ADDENDUM NO. 01

BCDM Architects
1015 North 98th Street, Suite 300
Omaha, Nebraska 68114

November 30, 2023

Arnold Elementary – Addition & Renovation
5000 Mike Scholl Street
Lincoln, NE 68524
&
Huntington Elementary Renovation
2900 North 46th Street
Lincoln, NE 68504
BCDM Project No. 5370-01

1 FLOOR PLAN

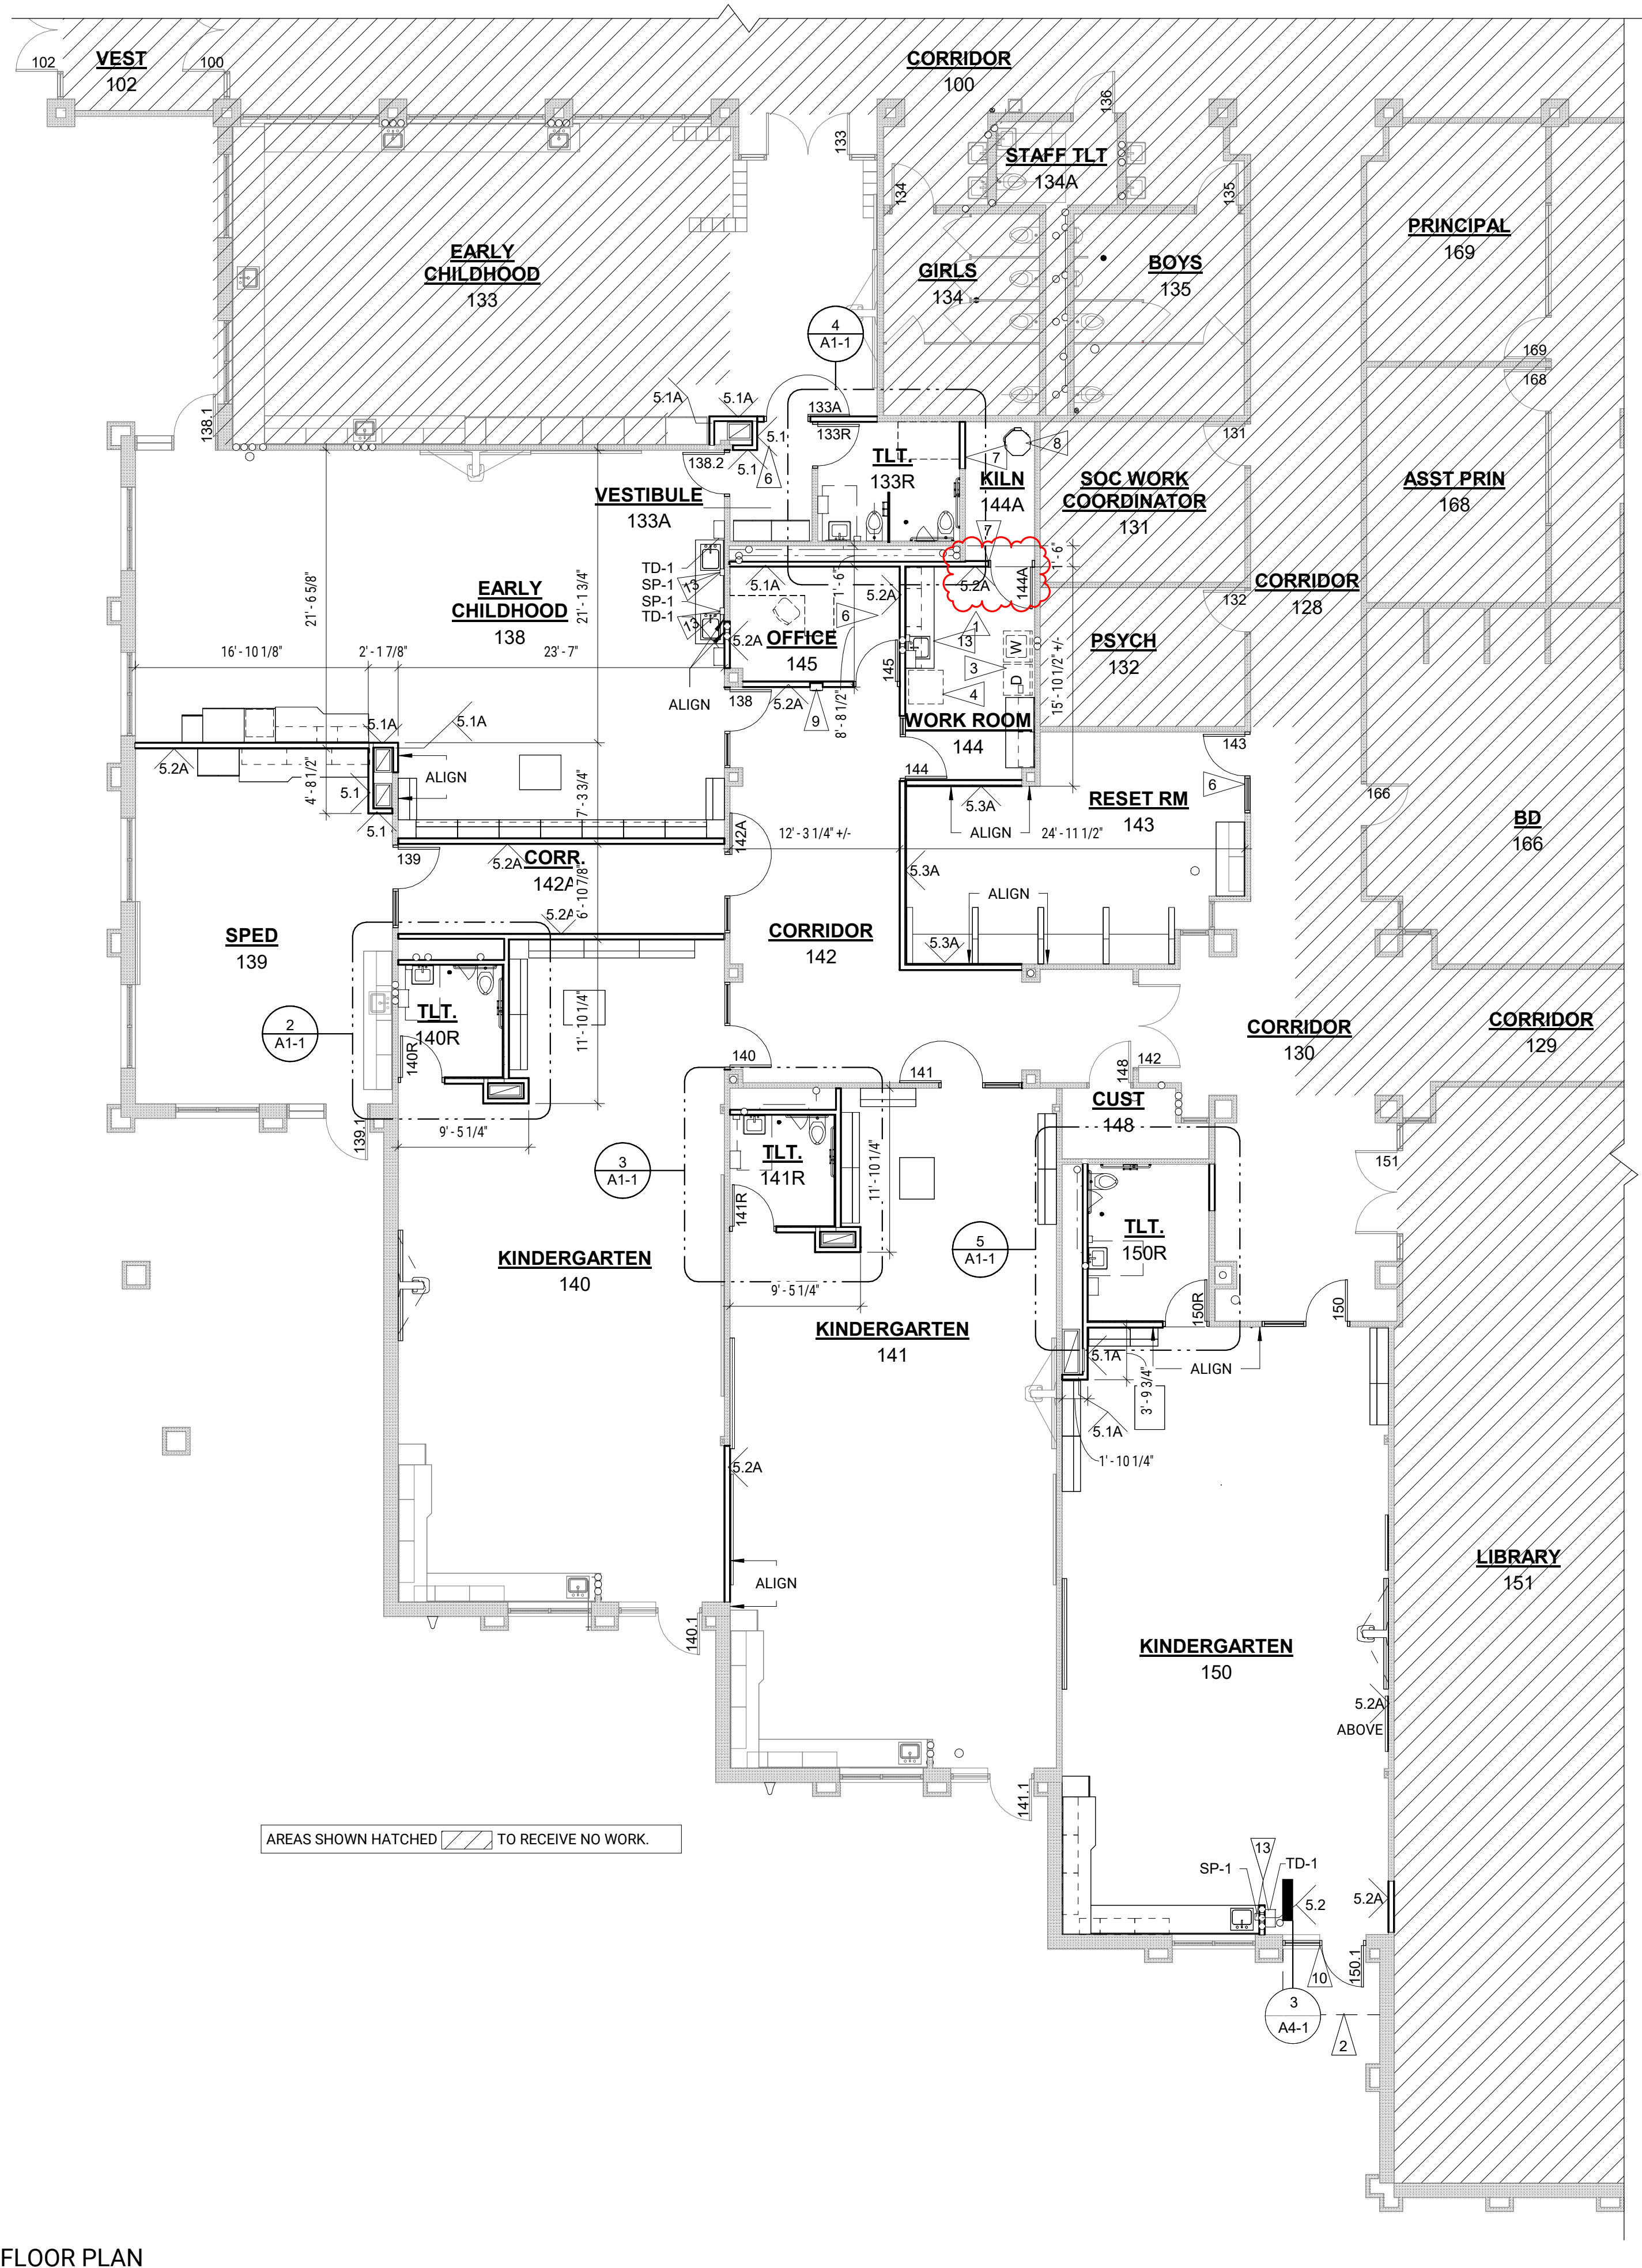
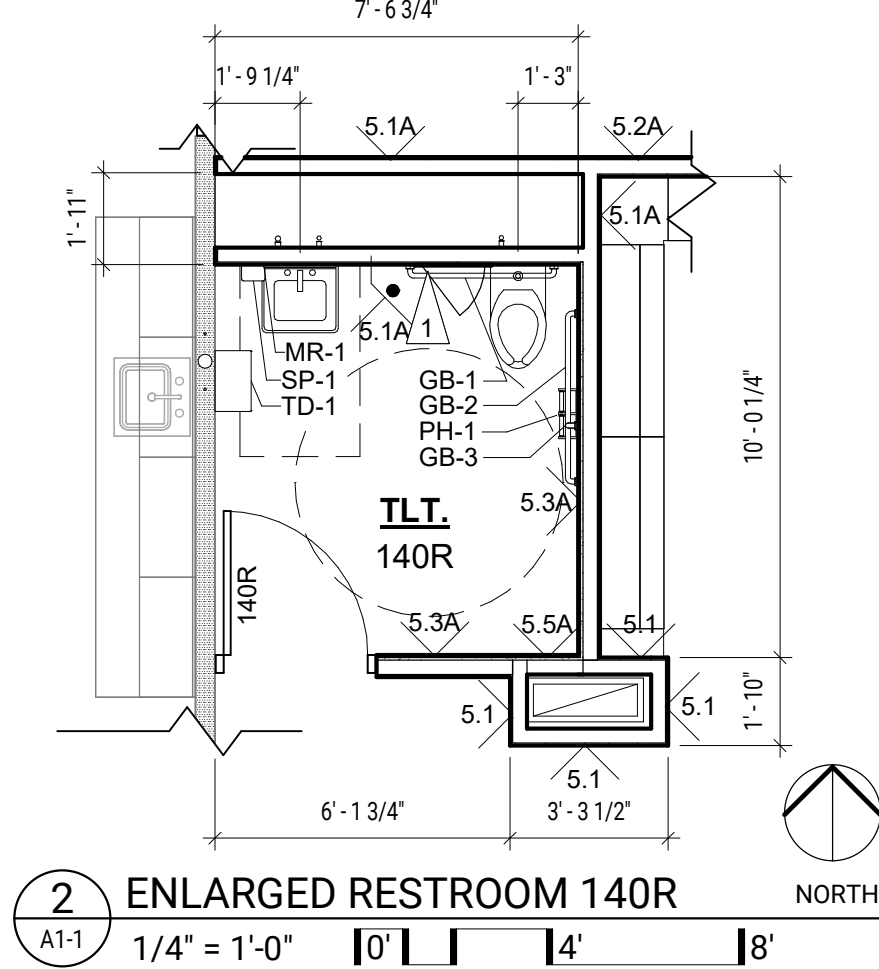
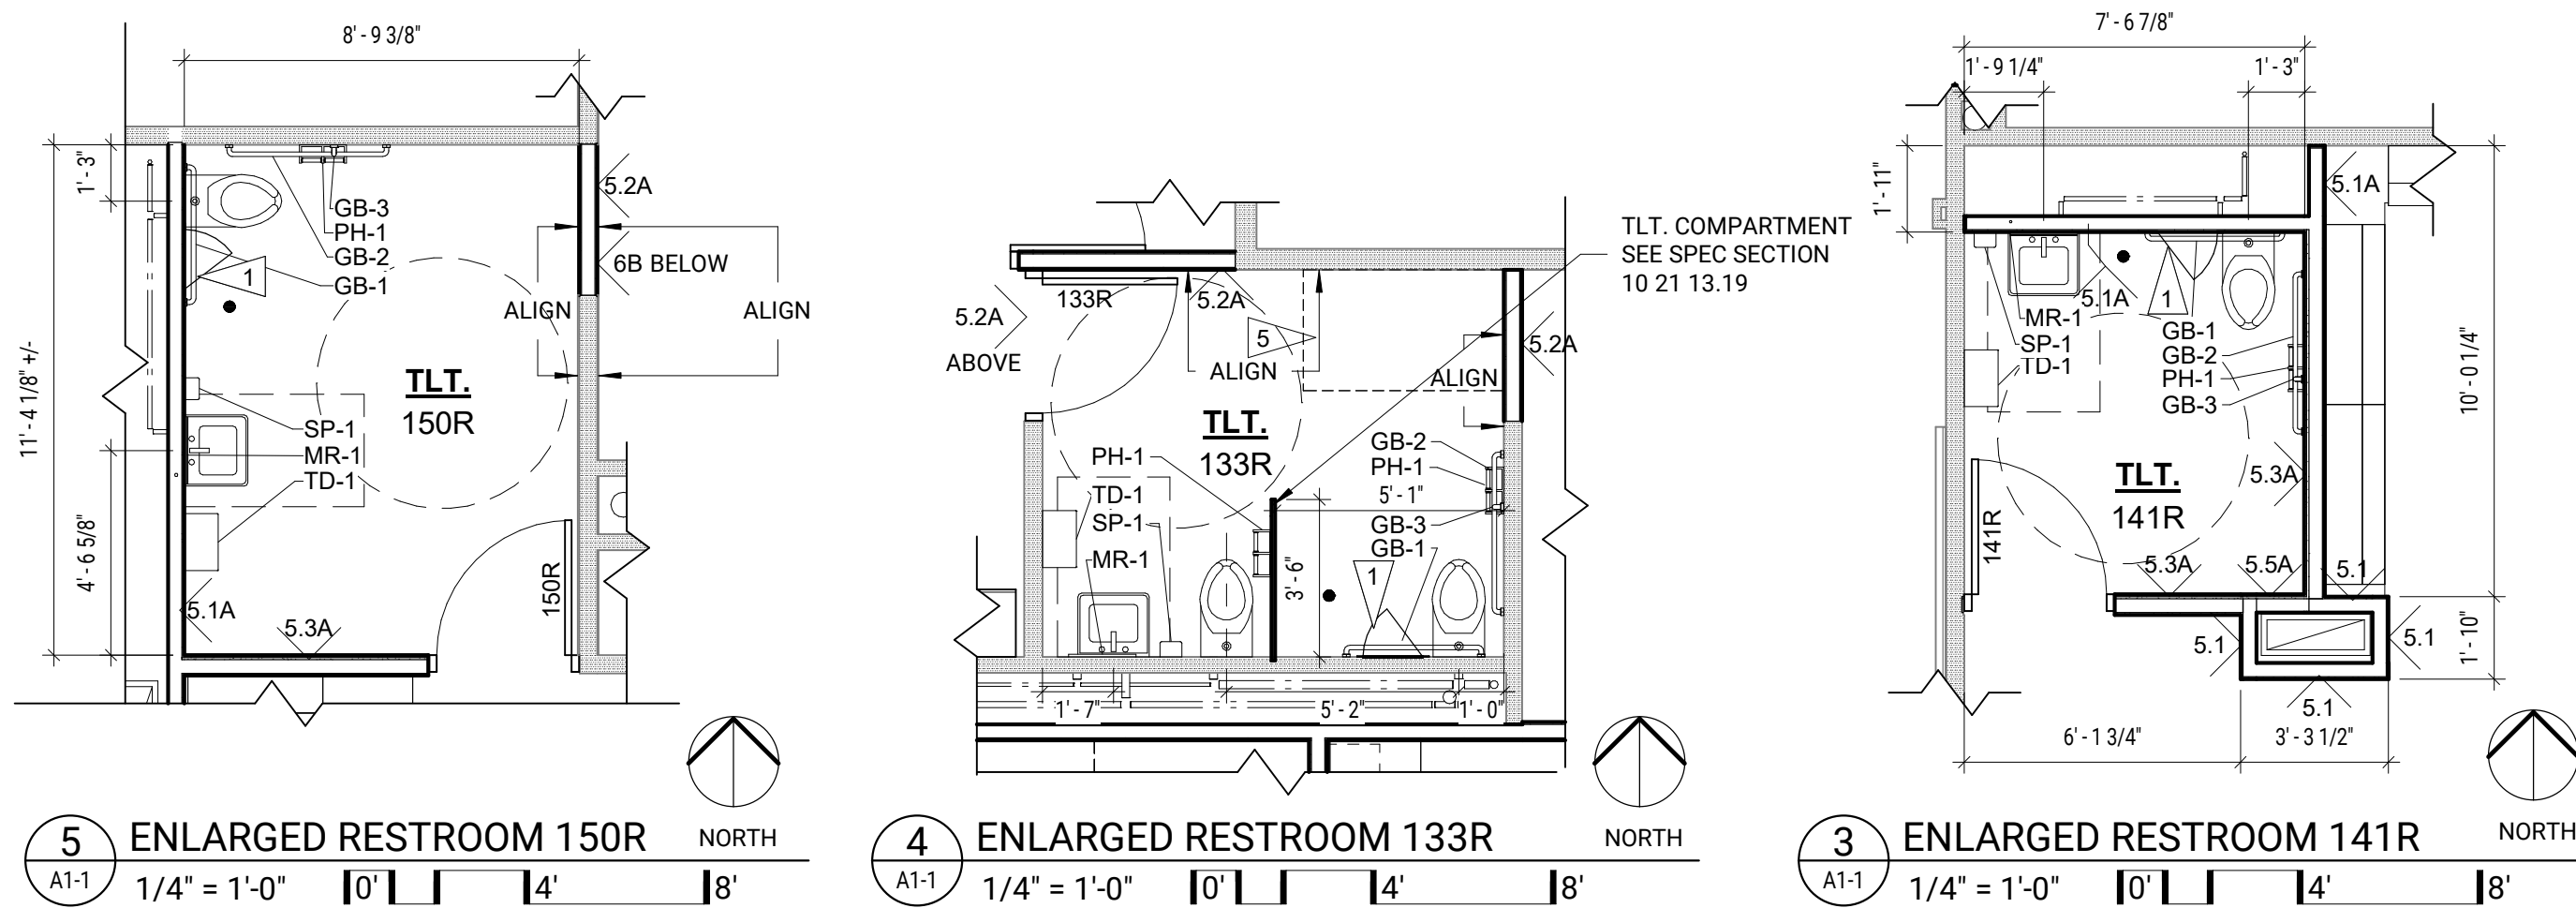
HUNTINGTON SHEET A1-1, FLOOR PLAN

- a. FLOOR PLAN, adjust Door No. 144A to HM wrapping frame.
b. FLOOR PLAN, adjust wall type at south wall of KILN 144A to be a 5.2A wall.
